Sid Commons Apartment Project

Response to Comments/Final Environmental Impact Report

SCH # 2007072041
Lead Agency: City of Petaluma
October, 2019

Sid Commons Apartment Project Responses to Comments / Final EIR

Letter E1 (continued)

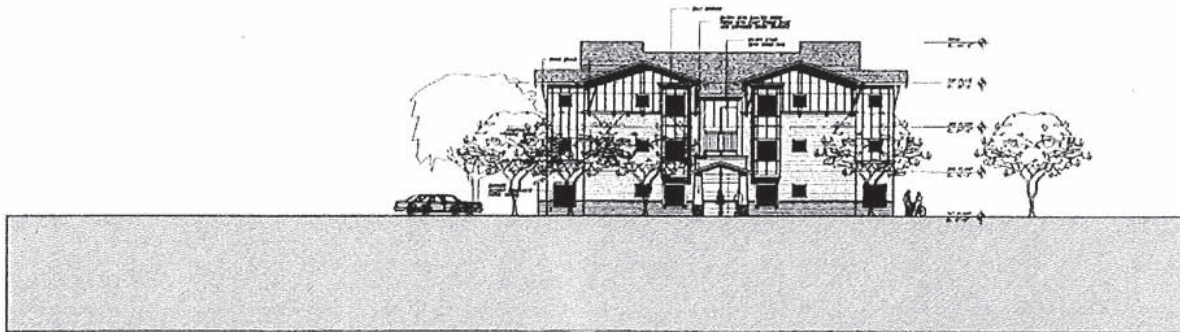
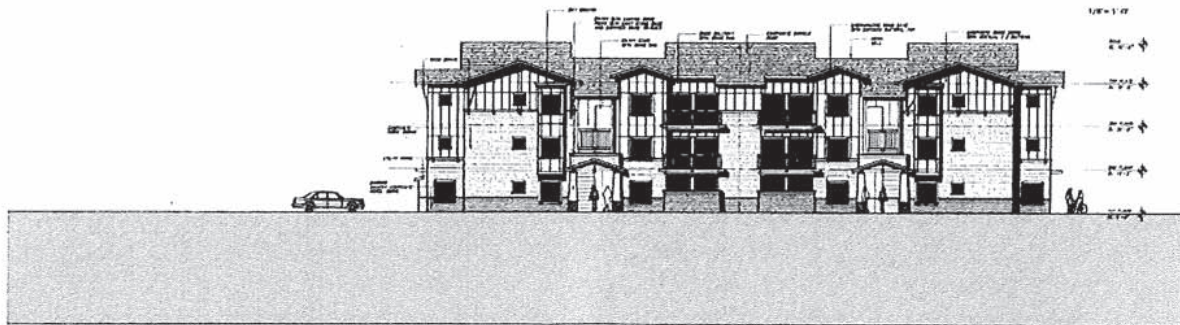
As explained in the attached peer review from Transpedia Consulting Engineers (“TCD”), the DEIR overestimates the ADT per unit, overestimates the percentage of Project-related trips that would use Graylawn Avenue, and fails to consider the effect that alternative modes of

¹ As discussed in the peer review from TCD, it appears that Graylawn Avenue should be classified as arterial roadway, as it has the design capacity to accommodate at least 6,000 ADTs. (Exhibit A, p. 5.)

The DEIR bases its ADT estimates on the Institute of Transportation Engineers (“ITE”) land use characteristics for “apartments” (ITE Land Use 220) rather than “mid-rise apartments” (ITE Land Use 223). “Apartments” have an ADT of 6.5. However, “mid-rise apartments,” defined as apartments “in rental buildings that have between three and 10 levels (floors),” have an ADT of approximately 4 daily trips.² The Project analyzed in the DEIR is three stories in height (see illustration from Figure 3-8 of the DEIR below).³ Applying the corrected figure of 4 ADT per dwelling unit, the 278 units proposed for the Project would create a total of only 1,112 ADTs.
